Contract #: 04-0120F4  
 Cty: SF/ALA Rte: 80 PM: 13.2/13.9  
 File #: 69.25B

**QUALITY ASSURANCE -- NON-CONFORMANCE REPORT**

**Location:** Changxing Island, Shanghai, China **Report No:** NCR-000834  
**Prime Contractor:** American Bridge/Fluor Enterprises, a JV **Date:** 07-Sep-2010  
**Submitting Contractor:** Zhenhua Port Machinery Company, Ltd (ZPMC), Changxing Island **NCR #:** ZPMC-0796

**Reference Description:** Base Metal Repair without Prior Approval from Engineer

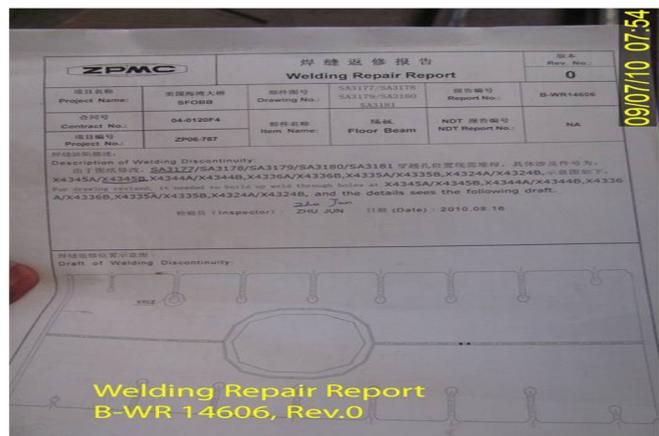
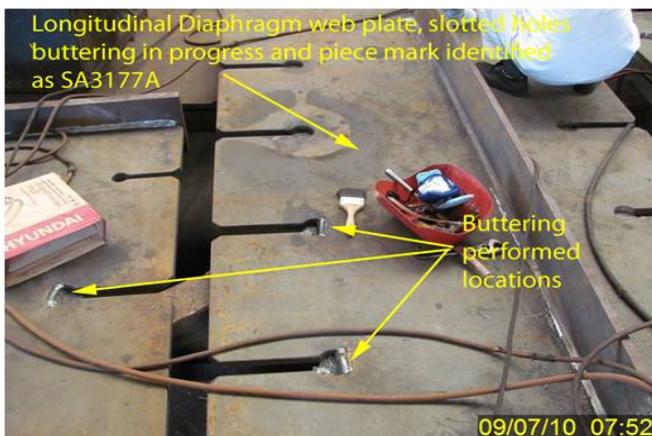
- During Quality Assurance Inspection of fabrication in Bay#2 QA discovered the following issue:
- Base metal repair being performed by ZPMC personnel without Engineers approval.
  - The base metal repairs were being performed in the area of the cope holes at the top of the stiffener pass through slots in the web plates.
  - ZPMC is building up the inside of all the cope areas to accommodate a drawing revision.
  - Additionally ZPMC did not appear to prepare the edge of the material in a manner suitable for building up the edges as specified in ABF submittal 200.
  - The members are identified as SA3177A, SA3177B, SA3179A, SA3179B, SA3178A, SA3178B, SA3158A and SA3177B.
  - ZPMC personnel were performing the weld repairs per Weld Repair Report (WRR) B-WR14606.
  - The Longitudinal Diaphragm components are located in Bay 2.

Reference attached pictures.

ZPMC acknowledges that base metal repairs require Engineer approval. In this case, the floor QC thought that since this repair was the result of drawings revisions a WRR was sufficient. This point has been clarified to prevent future occurrences. Subsequently ZPMC has submitted and received an approved CWR for this work. ZPMC is providing NDT after the repair to show that work done is acceptable. Based on this ZPMC requests closure of this NCR.

The proposed resolution is acceptable. This NCR is considered closed.

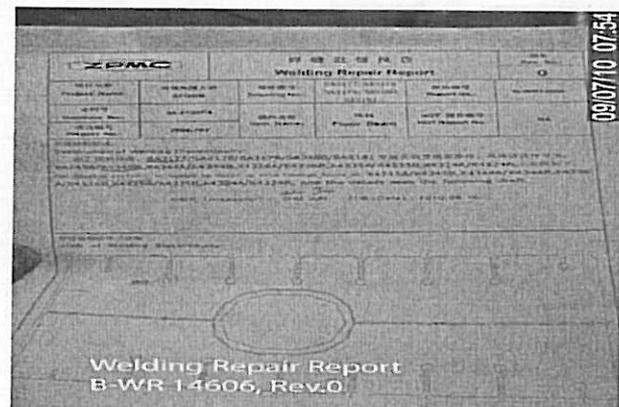
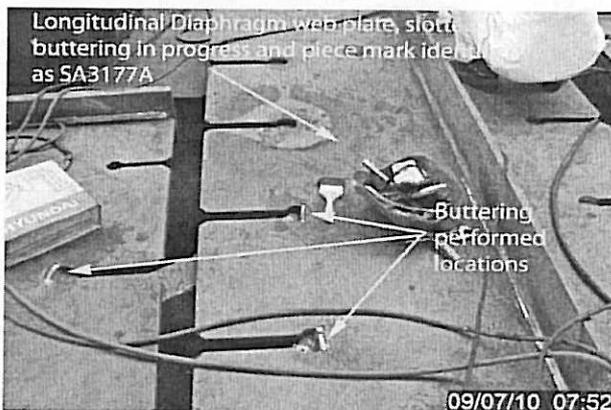
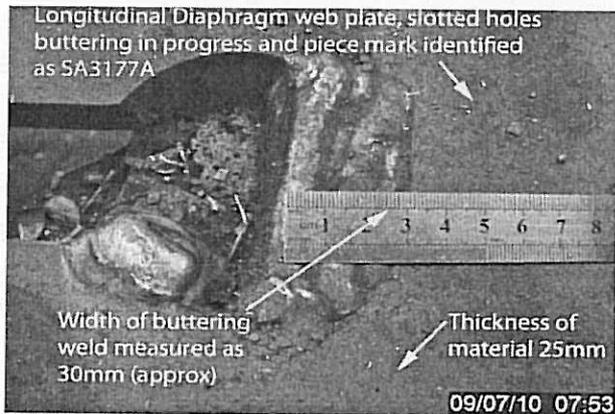
- Base metal repair being performed by ZPMC personnel without Engineers approval.
- The base metal repairs were being performed in the area of the cope holes at the top of the stiffener pass through slots in the web plates.
- ZPMC is building up the inside of all the cope areas to accommodate a drawing revision.
- Additionally ZPMC did not appear to prepare the edge of the material in a manner suitable for building up the edges as specified in ABF submittal 200.
- The members are identified as SA3177A, SA3177B, SA3179A, SA3179B, SA3178A, SA3178B, SA3158A and SA3177B.
- ZPMC personnel were performing the weld repairs per Weld Repair Report (WRR) B-WR14606.
- The Longitudinal Diaphragm components are located in Bay 2.

Reference attached pictures.

- ZPMC QA personnel talked with on-site QC to address the requirement of "prior approval of the engineer".
- Submit Critical Weld Repair (CWR) for the job record.
- Repair and inspect accordingly to the CWR.

- Discussed the issue with onsite QC staff.
- Performed repair and inspection according to the approved critical weld repair.
